LLDP Text¹: Only sections with changes are included.

Clause 79

79.3 IEEE 802.3 Organizationally Specific TLVs

Figure 79-3—Power Via MDI TLV format

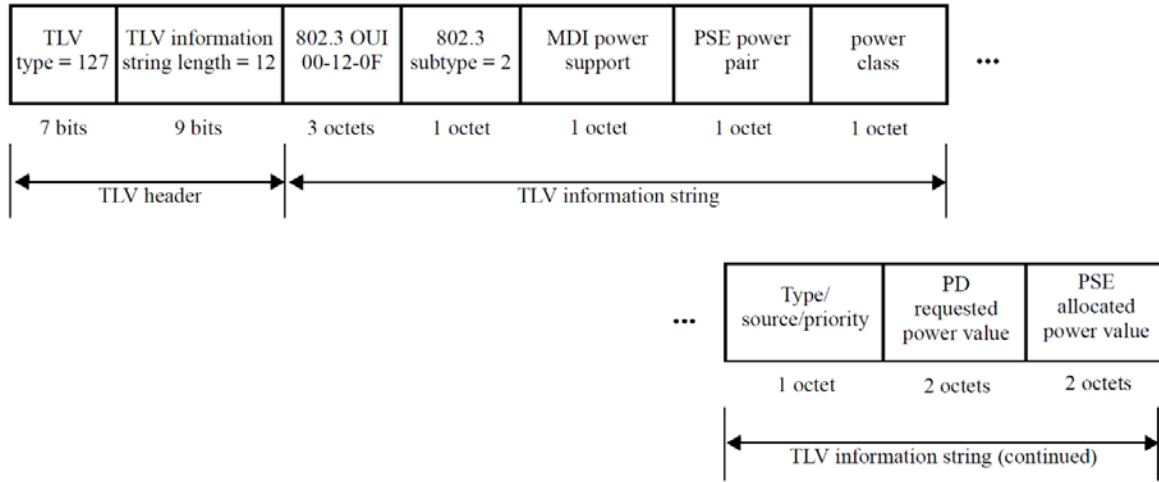
Restore Figure 79-3 from 802.3-2012, change caption to “Power via MDI TLV format for Type 1 and Type 2”

Figure 79-3a—Power Via MDI TLV format for Type 3 and Type 4

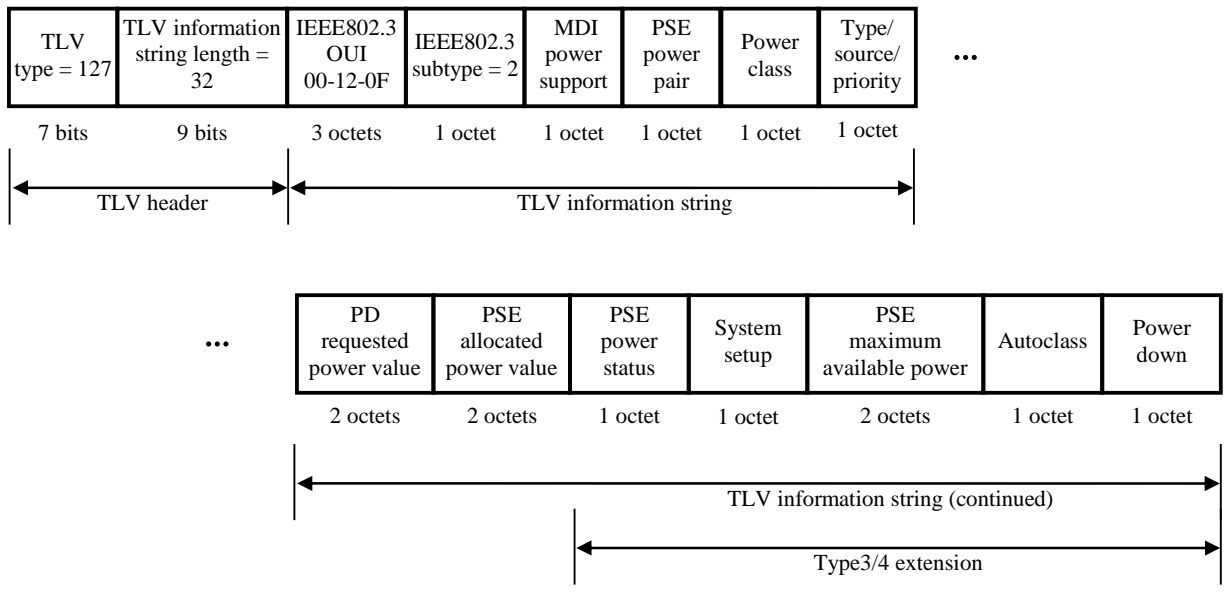
To support also long MDI TLVs a second frame size is defined as shown in Figure 79-3a

Figure 79-7a—Power Via MDI Measurements TLV format for Type 3 and Type 4**79.3.6.1 PD measurements**

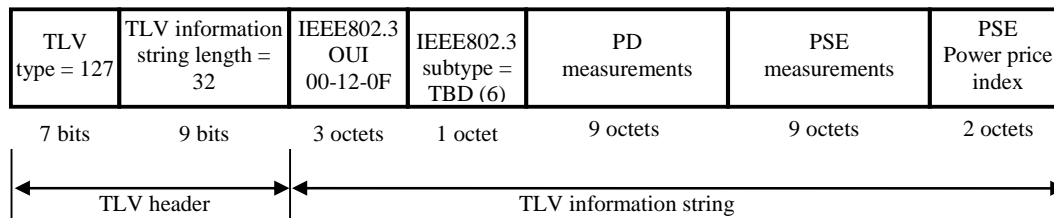
Clause 33 defines two option power entities: a Powered Device (PD) and Power Sourcing Equipment (PSE). These entities allow devices to draw/supply power over the sample generic cabling as used for data transmission. The Power Via MDI Measurement TLV allows network management to read electrical measurement data from the sending IEEE 802.3 LAN station. Figure 79-7a shows the format of this TLV.
